RELEVANT INFORMATION FOR COUNCIL

SUBJECT: Information Relevant To Item 9.10 – Development Application: 223-225

Liverpool Street, Darlinghurst - At Council - 27 February 2017

Alternative Recommendation

Figure 1: Proposed Colourbond roof in 'Terrain' colour

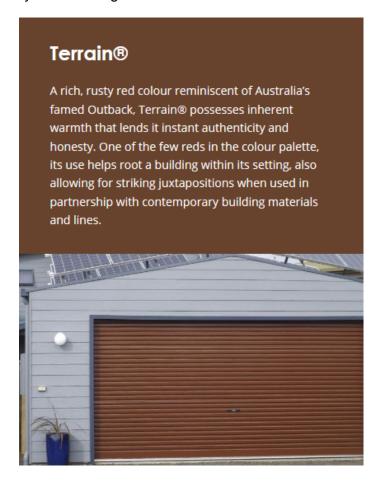
• Councillors asked for some information about the materials of the roof top having regard to reducing potential glare to surrounding apartments.

Response: The applicant has confirmed that the material to be used for the roof is Colorbond in a colour known as Terrain which is shown in Figure 1 below. The applicant confirms that a similar colour will also be used for the proposed screening of the roof plant. The colour has been chosen to complement the proposed finishes of the upper level structure but the applicant is prepared to consider other colours if preferred by Council.

The design details of the proposed building façade, including all external finishes, colours and glazing, must be in accordance with the materials schedule and sample board, and specifications prepared by Fender Katsalidis Mirams Architects (FKM) submitted with the development application dated 17 June 2016. The roof and the louvered screen to the plant room are to both be a Colorbond material in the colour 'Terrain'.

A standard reflectivity condition has been recommended (as detailed above) that requires the visible light reflectivity from building materials used on the facade and roof to not exceed 20%.
